Project	IEEE 802.16 Broadband Wireless Access Working Group < http://ieee802.org/16 >
Title	OFDMA PHY AAS Enhancements
Date Submitted	[2004-03-15]
Source(s)	<p>Panyuh Joo, Seungjoo Maeng, Jaeho Jeon, Soonyoung Yoon, Jeong-Heon Kim, Jaehyok Lee, Myungkwang Byun, JeongTae Oh, Wonil Roh, Inseok Hwang, Jaehee Cho, Sanghoon Sung, Hun Huh, Jiho Jang, Ikbeom Lee, HeeSang Seo, Sijun Cho, Chiwoo Lim, Youngbin Chang, Jaeweon Cho, Jaeyoel Kim, Sung-Eun Park, Samsung Electronics Co. Ltd.</p> <p>John Liebetreu, Jeff Foerster, Jose Puthenkulam, Randall Schwartz, David Johnston, Hassan Yaghoobi, Intel Corporation</p>
Re:	Working Group Review of P802.16-REVd_D3
Abstract	
Purpose	To propose AAS related enhancements to the OFDMA PHY in 802.16REVd_D3 draft for better performance in a broad set of channel widths.
Notice	This document has been prepared to assist IEEE 802.16. It is offered as a basis for discussion and is not binding on the contributing individual(s) or organization(s). The material in this document is subject to change in form and content after further study. The contributor(s) reserve(s) the right to add, amend or withdraw material contained herein.

1 **OFDMA PHY AAS Enhancements**

11
 12 **Figure 1 – Frame structure for AAS**

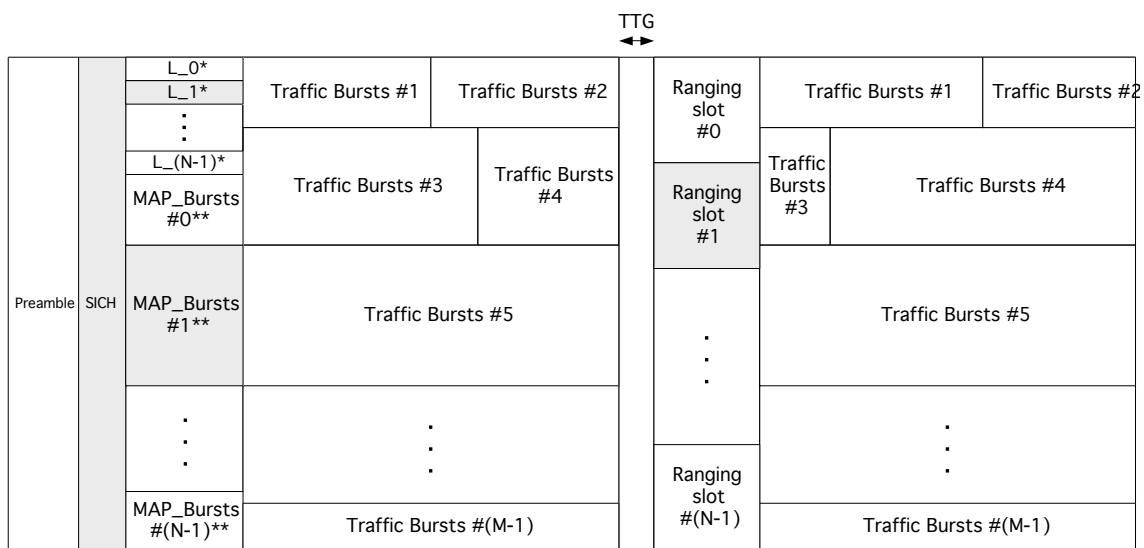
17 When operating in the AAS mode, only AMC subchannelization is used for uplink and downlink traffic bursts. Downlink
 18 frame structure can be divided into preambles, SICH, MAP bursts, and traffic bursts. Uplink frame structure can be divided
 19 into ranging and traffic bursts. Uplink control channels may be transmitted within traffic burst region in AAS mode.

* L_n : AAS_MAP_Burst_Location_IE for beam direction #n
 ** MAP_Burst #n : Indicates three mini_MAP_Bursts for beam direction #n
